# Service Bulletin

Bulletin No.: PI0432C

**Subject:** Shorter Front Bumper Fascia Air Deflector Available for Service

**Models:** 2011-2013 Chevrolet Volt

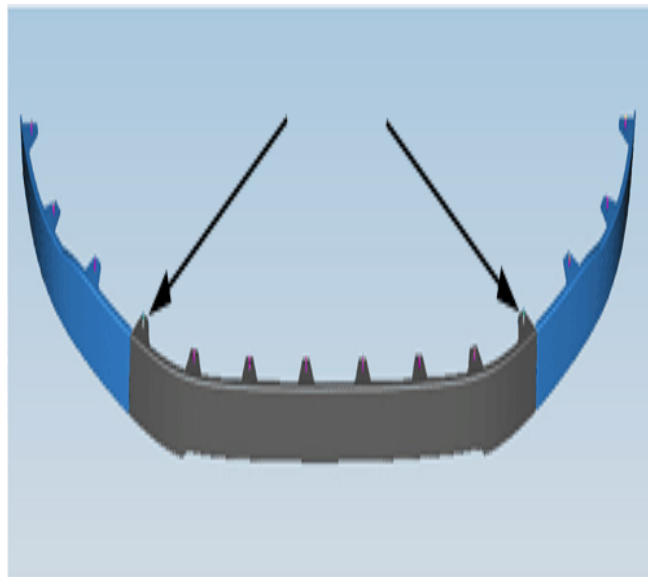
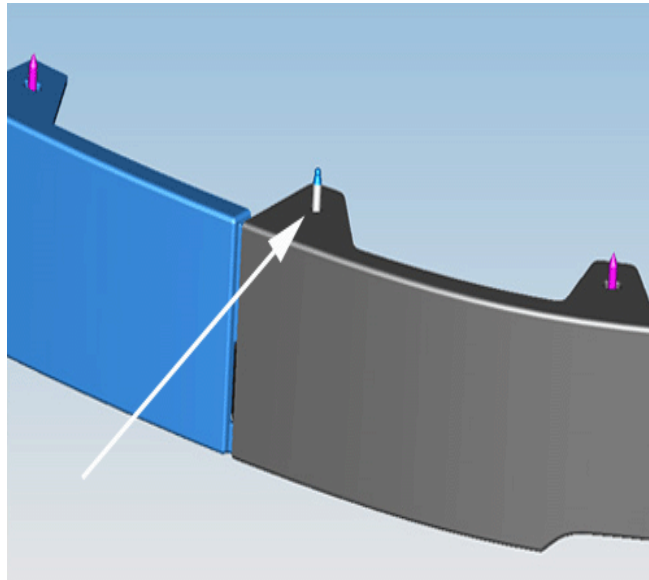
Some customers may comment about the low ground clearance of the front bumper fascia air deflector. The air deflector contacts the ground, scraping at short inclines, because there is not enough clearance between the ground and the front bumper fascia air deflector on an inclined surface.

A shorter front bumper fascia air deflector is available for service. Customers have the option to install the front bumper fascia air deflector, which has a higher clearance. The current clearance is 95 mm (3.7 in), the shorter front bumper fascia air deflector brings the clearance up to 125 mm (4.9 in).

2582397

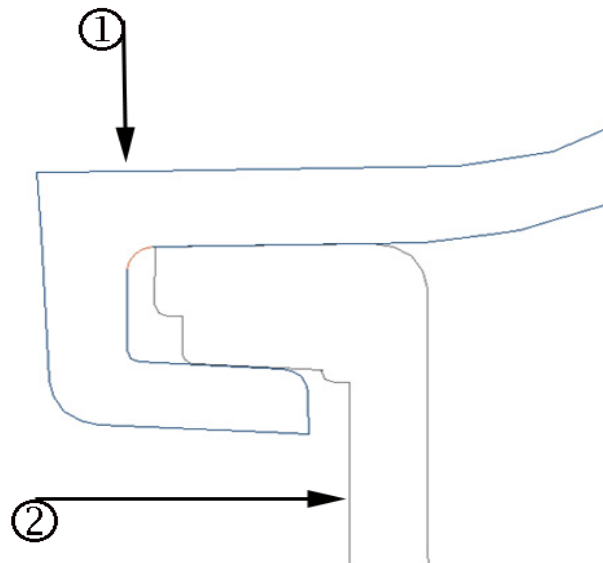
1. The two screws shown above are preinstalled at the plant and need to be removed from the wheelhouse liner prior to air deflector installation. Reinstall these screws first when installing the air deflector.

2592681

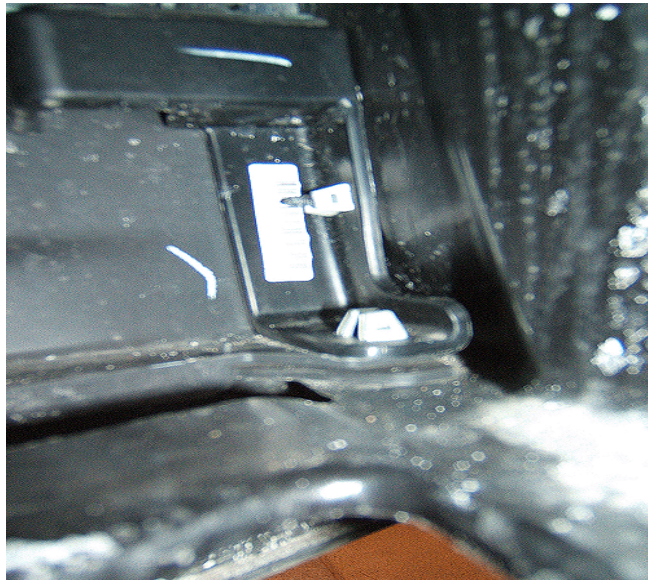
2. The air deflector (2) needs to be fully seated into the "C" channel on the lower fascia (1) as part of the assembly. Insertion into the "C" channel is a tight fit.
3. Prior to installing the screws, line up all three pieces of the air dam to the fascia first.
